Subject: Duane Arnold Energy Center  
Docket No: 50-331  
Op. License No: DPR-49  
Response to Request for Additional Information (RAI) to Request for  
Operating License Change (TSCR-040) – Revised Thermal-Hydraulic  
Analysis for the Spent Fuel Pool. (TAC # MB0596)

DAEC's Response to  
NRC Staff's Request for Additional Information  
Regarding the Thermal-Hydraulic Evaluation of the DAEC Spent Fuel Pool

Figure 1 - Reactor Heat Generation for Cases 1 and 2 from Revision 4

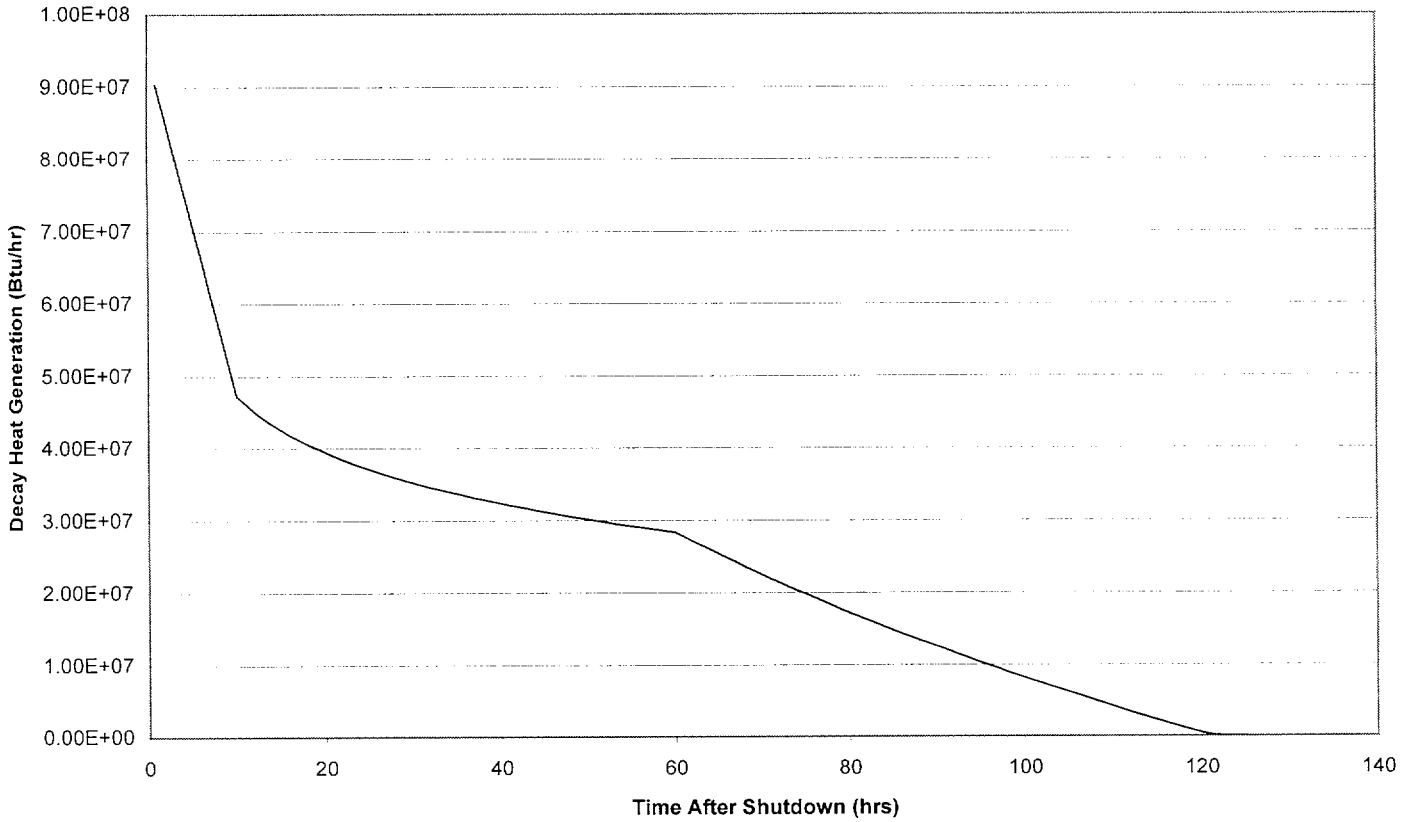
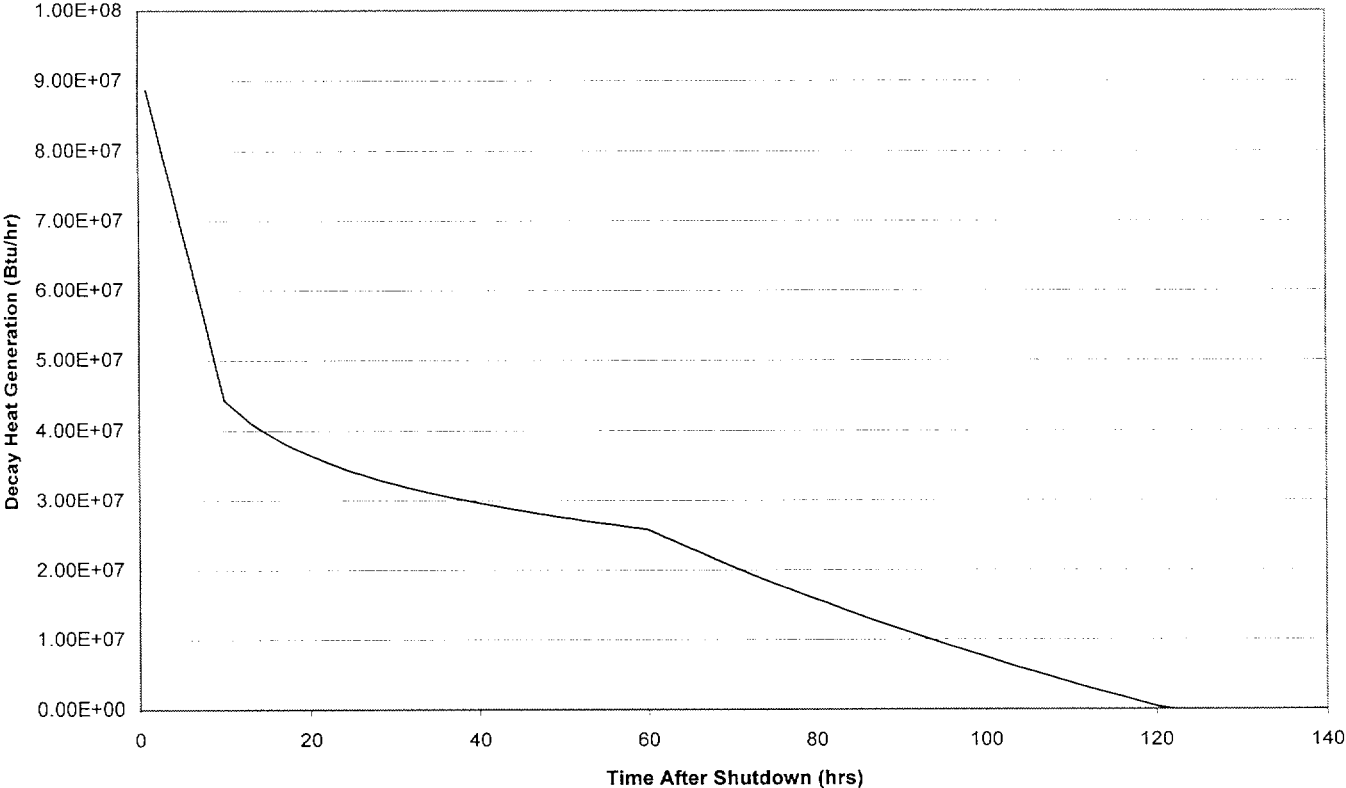
4. With regard to the decay heat in the reactor cavity vessel, please provide the following additional information.
  - a. The decay heat in the reactor vessel cavity as functions of time (similar to Figures 4-6) for all scenarios analyzed. This information is needed since the RHR removes the heat from both reactor vessel cavity and SFP.
  - b. The decay heat in the reactor cavity vessel of the same cases for Revision 2 for comparison.

*See Attachment 2, Figures 1 and 2 for reactor decay heat curves from Revision 4 and Figure 3 for the reactor decay heat curve from Revision 2.*
